SUBJECT: Cal City Substation 115 kV Upgrade Project – Data Request 2

## Data Request 2 Cal City 115 kV Substation Upgrade Project CEQA Evaluation

Area map display of Kramer, Holgate, Edwards stations and 115 kV.

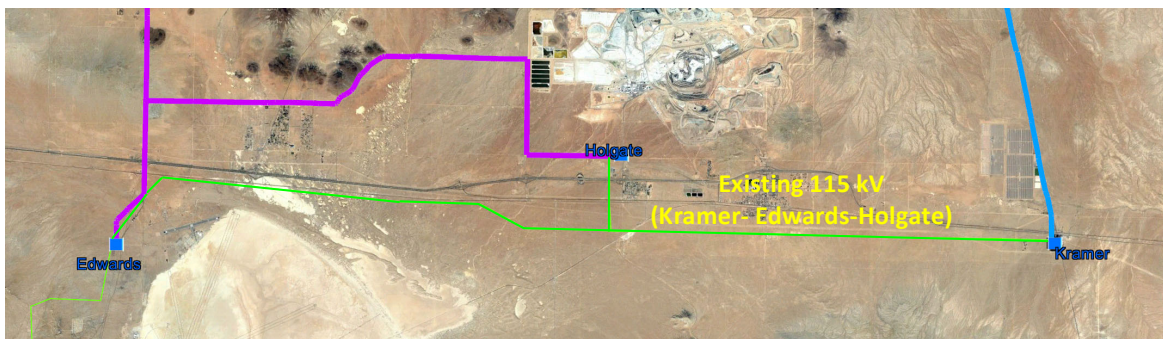
6. Section 1.1.2.1, *Subtransmission*: Please verify there is currently a 115 kV line from Holgate to Edwards (Kramer-Edwards-Holgate 115 kV) to support the new Cal City-Edwards-Holgate 115 kV Subtransmission Line. Refer to attached map display.
